REMARKS

IN THE DRAWINGS:

Please approve the drawing changes as shown in red in the attached marked-up copies of Figs. 11A-18B. A separate Letter to the Draftsman indicating the same proposed drawing changes is also enclosed.

FIG. 12C
(PRIOR ART)

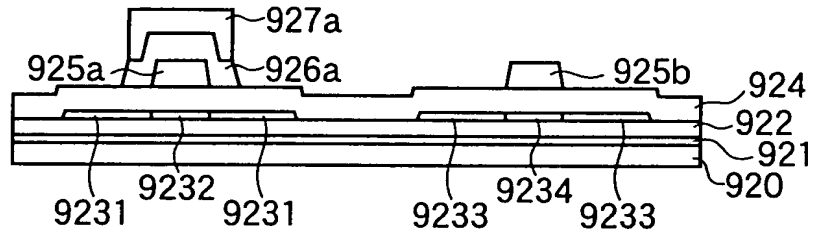
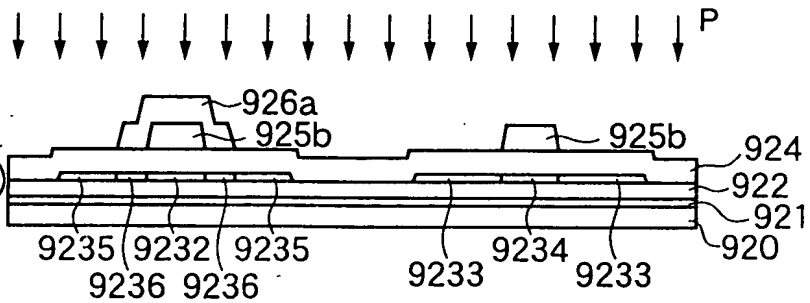
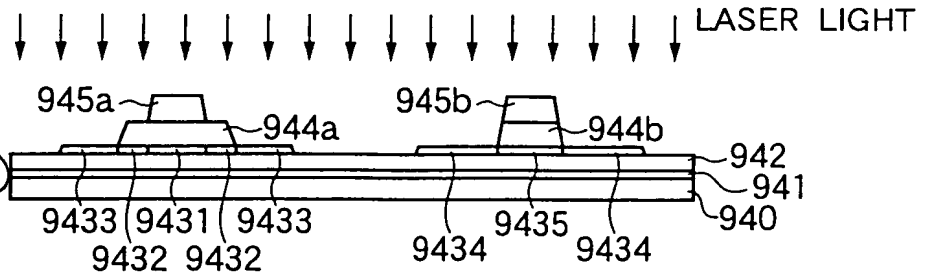
The Examiner, on page 5 of the outstanding Office Action, asserts that the insulation film 924 of the AAPA is analogous to the first insulation film of the present invention, and that the source/drain regions “2935” are analogous to the source and drain regions formed on the substrate in the present invention. Applicants presume that the

Examiner though, meant to refer to the source/drain regions 9235 featured in Fig. 12C of the present Application, which represents the AAPA. Fig. 12C though, clearly illustrates that the insulation film 924 is *not* formed only on channel regions and low density impurity regions, but is also formed over the source/drain regions 9235.
